Access Compliance Report

Public Rights-of-Way

Intersection ID: 15397	Main Street: N_WENDOVER_RD	Cross Street: N_WENDOVER_RD_RA	Location:	N
ADA ID: EB3055398B88	Ramp Type: Perp	Initial Pass/Fail: Fail	Overall Compliance: No	Severity Score: 12.5
Codes/Mitigation Info/Possible Solution		Field Measurements/Component Compliance

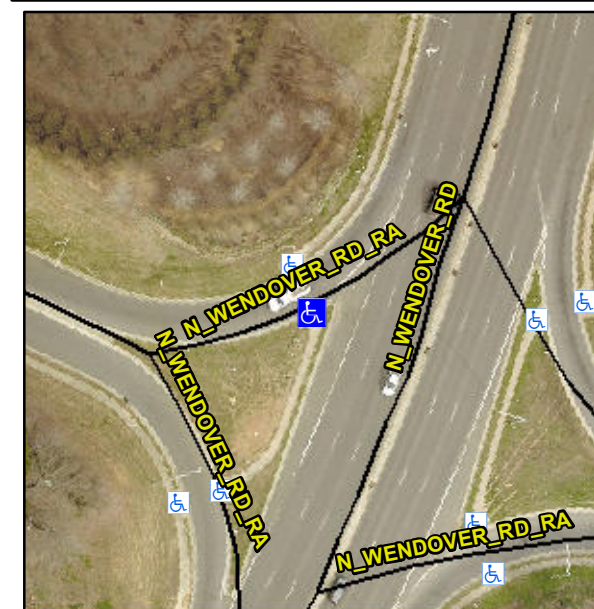
Not Found, R304.2.2

Compliance	Description	Data	Compliance	Description	Data
N/A	Ramp Length (in)	94.0	No	Ramp Slope (%)	9.9
Yes	Ramp Width (in)	56.5	Yes	Ramp XSlope (%)	1.6
N/A	Flare Type LT	N/A	N/A	Flare Type RT	N/A
N/A	Flare Slope LT (%)	N/A	N/A	Flare Slope RT (%)	N/A
N/A	Flare Traversable LT?	N/A	N/A	Flare Traversable RT?	N/A
N/A	Landing Length (in)	N/A	N/A	DWS Provided?	N/A
N/A	Landing Width (in)	N/A	N/A	DWS Contrast?	N/A
N/A	Landing Slope (%)	N/A	N/A	DWS Length (in)	N/A
N/A	Landing X Slope (%)	N/A	N/A	DWS Full Width?	N/A
N/A	Landing Curb? (Y/N)	N/A	N/A	DWS Offset (in)	N/A
N/A	Shared Landing?	N/A			
N/A	Gutter Ponding?	N/A	N/A	Gutter Slope (%)	N/A
N/A	Gutter Lip Ht (in)	N/A	N/A	Gutter X Slope (%)	N/A
N/A	Painted X Walk1?	No	N/A	Painted X Walk2?	N/A
	X Walk 1 Direction	To NW		X Walk 2 Direction	N/A
N/A	X Walk 1 Width (in)	N/A	N/A	X Walk 2 Width (in)	N/A
	X Walk 1 Slope (%)	6.0		X Walk 2 Slope (%)	N/A
	X Walk 1 X Slope (%)	2.9		X Walk 2 X Slope (%)	N/A

Remove & Replace Entire Ramp.
